**Proposal #08: 1146-75-73, WISC 2023581**  
**STH 76 – New London**  
**CTH T/Givens Road – USH 45**  
**STH 15**  
**Outagamie County**

This is Addendum No. 03, which provides for the following:

**Addendum No. 03**  
**ID 1146-75-73**  
**Revised Sheet 142**  
**August 3, 2023**

Addendum No. 03  
ID 1146-75-73  
Revised Sheet 143  
August 3, 2023

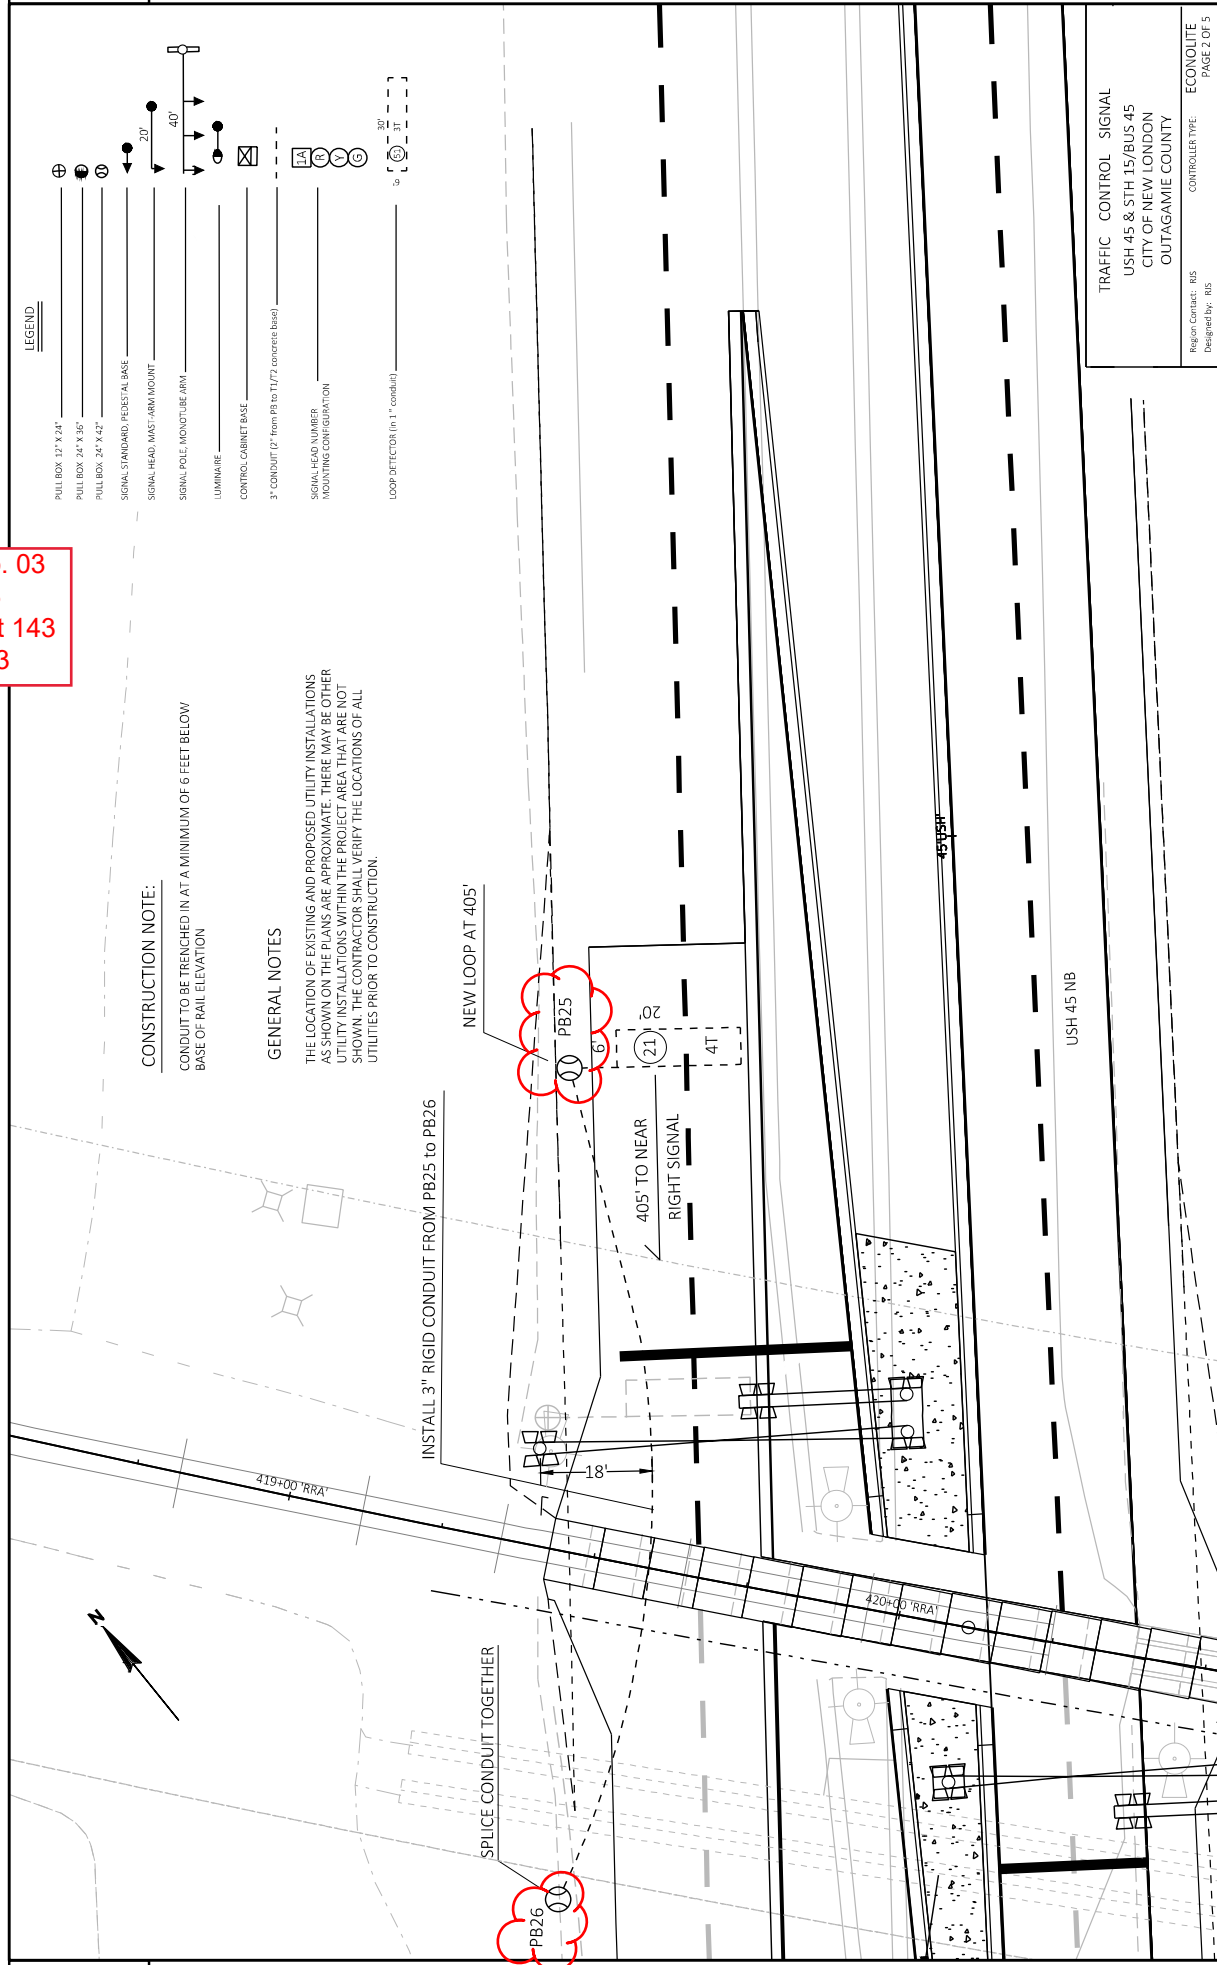
Revised Plan Sheets	
Plan Sheet	Plan Sheet Title (brief description of changes to sheet)
142	Traffic Control Signal – S68-0859 (Reduced number of Pull Boxes Steel 12x24-Inch and increased number of Pull Boxes Steel 24x42-Inch)
143	Traffic Control Signal – S68-0859 (Reduced number of Pull Boxes Steel 12x24-Inch and increased number of Pull Boxes Steel 24x42-Inch)
251	Miscellaneous Quantities (Reduced number of Pull Boxes Steel 12x24-Inch and increased number of Pull Boxes Steel 24x42-Inch)
